2 Type of change

Change of rating marks on the product.

Product Change Notification					DD11 Power entry module		
owner	creation date	release date	released by	change order no	rev	page	D10-032-542
sariogar	05.12.2018	06.12.2018	limachcl	2016776	A	1 of 2

Old product rating	New product rating
<p>With cover</p>  <p>Without cover</p> 	<p>With or without cover</p>

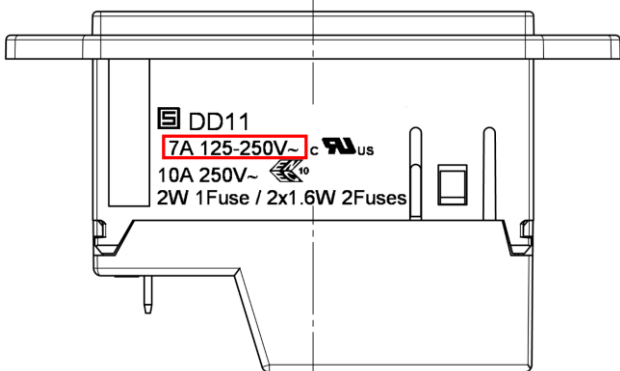
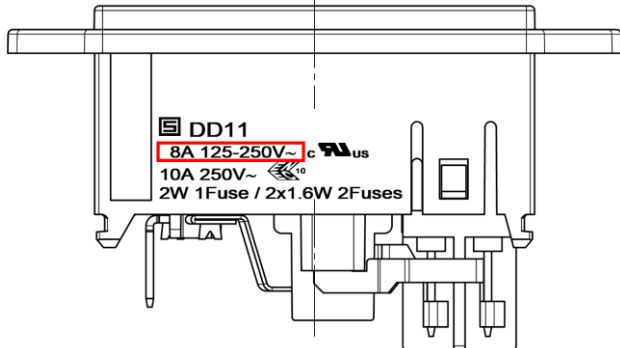
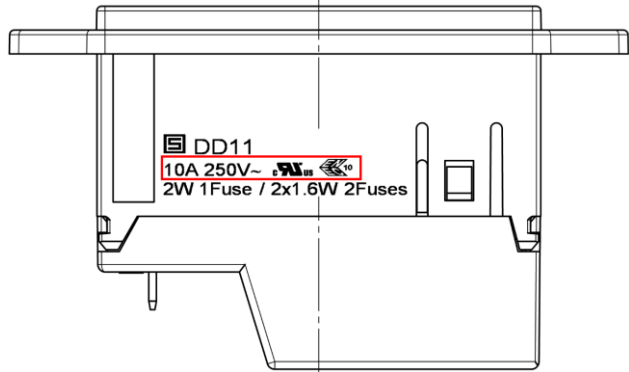
Standards update according to the new UL/CSA 60320-1.
